Your Ref
BE/42/19/DOC
Our Ref
PLAN-027584
Date
17/04/2019

Proposal: Approval of details reserved by condition imposed under ref BE/61/13/ relating to Condition Nos 17-eccology, 24-flood storage, 25-surface water drainage, 31-oil interceptor, 32- foul water sewerage, 33-watercourses, 34- SUDs and 39- Construction Management Plan.
Site: Oldlands Farm Cottages, Steyning Way, Bersted PO22 9NN.
BE/42/19/DOC

O.S. REF: SU9401NW

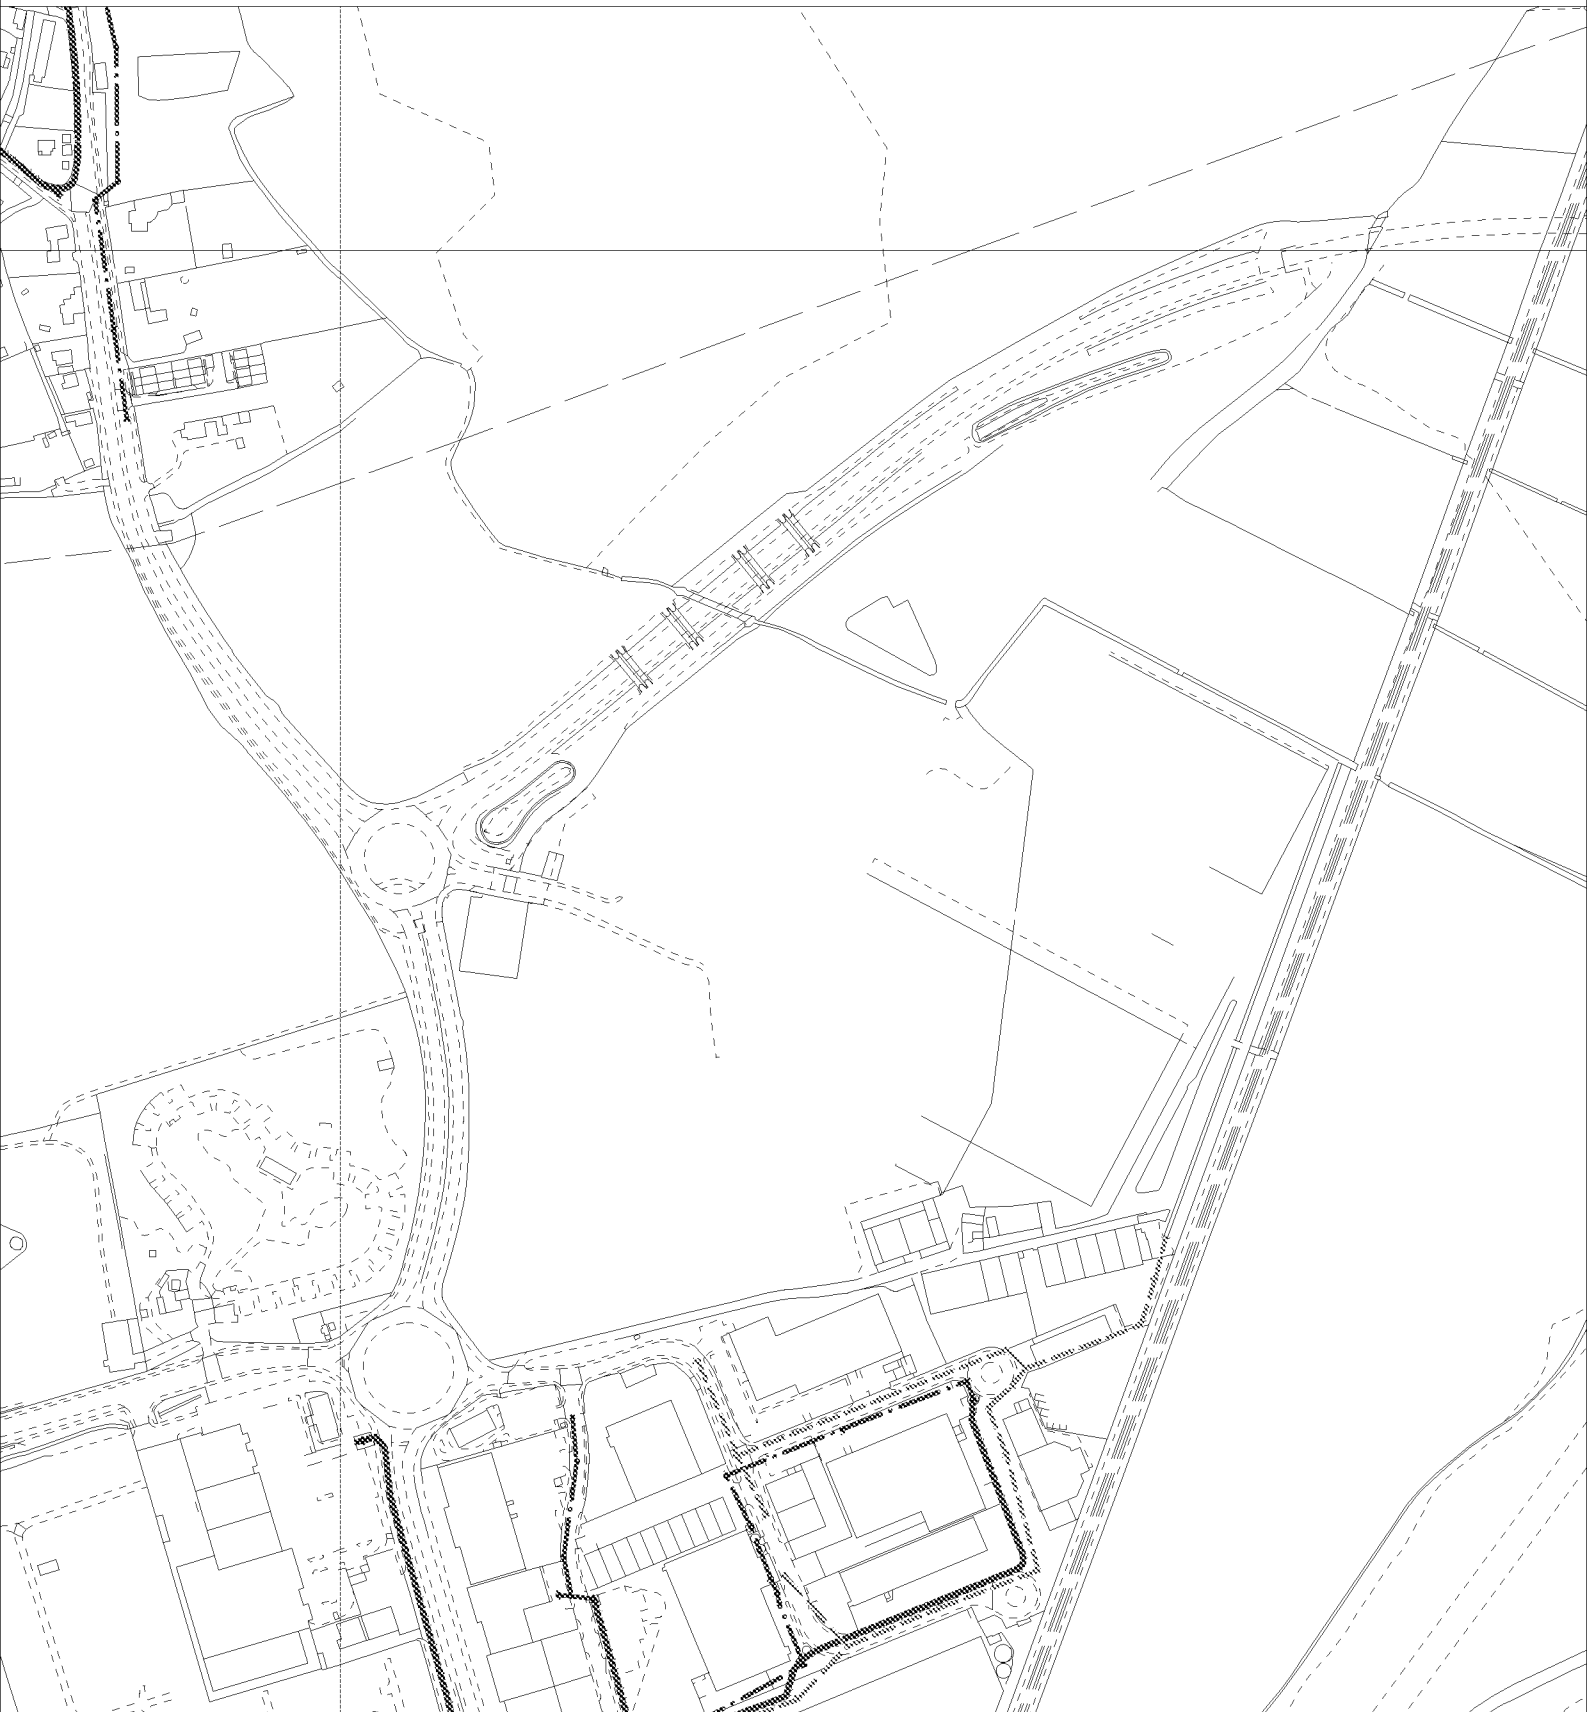
Please note: The nearest point where capacity is currently available is at Manhole reference number SU94001903.

Due to the vibration, noise and potential odour generated by sewage pumping stations, no habitable rooms should be located closer than 15 metres to the boundary of a proposed pumping station site.

swales, ponds, watercourses or any other surface water retaining or conveying features should be located within 5 metres of a public (also adoptable) sewers or water main.
